Contract #: 04-0120F4Cty: SF/ALA Rte: 80 PM: 13.2/13.9File #: 70.25B**QUALITY ASSURANCE -- NON-CONFORMANCE REPORT****Location:** Murooran Japan**Report No:** NCR-000140**Prime Contractor:** American Bridge/Fluor Enterprises, a JV**Date:** 04-Jun-2008**Submitting Contractor:** Japan Steel Works**NCR #:** JSW-0003**Type of problem:**

**NON-CONFORMANCE REPORT TRANSMITTAL**

**Subject:** NCR No. JSW-0003  
**Document No:** 05.03.06-000115

## NCR PROPOSED RESOLUTION

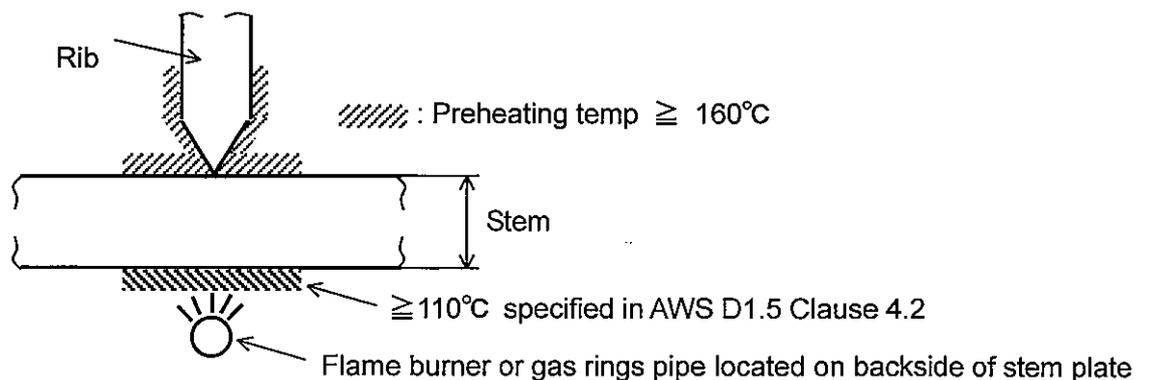
JSW explained the preheat temperature 160°C for tack weld could not be kept in wide area and whole thickness of the heavy plate because the large expansion of the material by preheat would disturb securing the tolerance limits of dimension of the structure.

It was the reason why the preheating was done only from the welded side when the Rib was tack welded to the Stem.

For tack welding of the Deviation Saddle W2E3, we would like to take following countermeasure. The temperature of opposite side of the Stem during tack weld should be higher than 110°C which is specified as minimum preheat temperature for A709 Gr.485W described in Clause 4.2 "Preheat and Interpass Temperature Requirement" of AWS D1.5.

When the temperature is not enough for tack weld by one side heating, preheat using a flame burner or gas rings set up partially from opposite side will assist. (Refer to the Sketch)

The Contractor/QC must ensure that the specified WPS preheat is met, in accordance with AWS requirements for all welding of structural steel. The preheat procedure must be reviewed and possibly modified should cracking of tack welds re-occur.
